Access Compliance Report Public Rights-of-Way (Curb Ramps)

Main Street: HARRISBURG_RD Cross Street: SHAKESPEARE_DR Location: W

ADA ID: RPAT211202093459 Ramp Type: Type 1 - Perpendicular Diagonal Initial Pass/Fail: Pass Overall Compliance: No Severity Score: 5

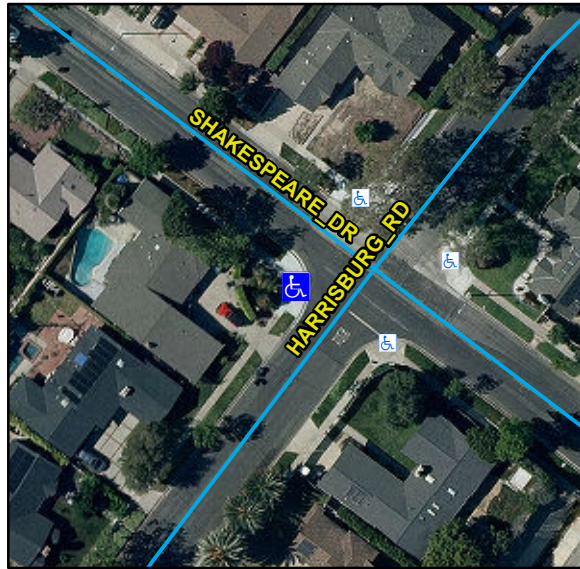
N/A	Ramp Inside Crosswalk 1	N/A	Yes	Ramp Inside Crosswalk 2	N/A
	Crossing 1 Slope (%)	2.2		Crossing 2 Slope (%)	2.2
	Crossing 1 Cross Slope (%)	0.8		Crossing 2 Cross Slope (%)	0.5
Yes	Gutter Ponding	No	Yes	Curb Slope	4.2
Yes	Gutter Lip Height (in)	0		Road Run Slope (%)	0.2
No	Gutter Run Slope (%)	6.8		Road Cross Slope (%)	3
Yes	Gutter Cross Slope (%)	1.2			
Yes	Overall Surface Condition: Acceptable		Yes	Perp Joint Present	Yes
	Cross Gutter Present?	No		Spandrel Present?	No
	Replace Cross Gutter?	N/A		Replace Spandrel?	N/A

Possible Solutions:

Remove & Replace Gutter.

R304.5.4, STD 1115
